## Access Compliance Report Public Rights-of-Way (Curb Ramps)

Intersection ID: 42684 Main Street: SHARON\_AV Cross Street: SHARON\_RD Location: SE

ADA ID: D31BB2B5E20B Ramp Type: PerpDiag Initial Pass/Fail: Fail Overall Compliance: No Severity Score: 33.75

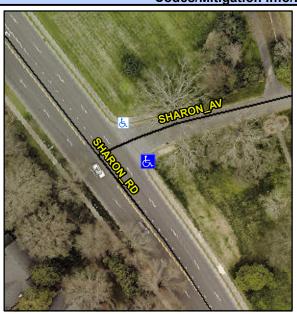
Not Found, R304.5.1, R304.5.3

| rield Measurements/Component Compilance |                       |       |      |                             |      |
|---|-----------------------|-------|------|-----------------------------|------|
| N/A                                     | Ramp Length (in)      | 62.0  | Yes  | Ramp Slope (%)              | 5.8  |
| No                                      | Ramp Width (in)       | 44.0  | No   | Ramp XSlope (%)             | 7.4  |

Remove & Replace Curb Ramp With Two New Directional Ramps or Equivalent.
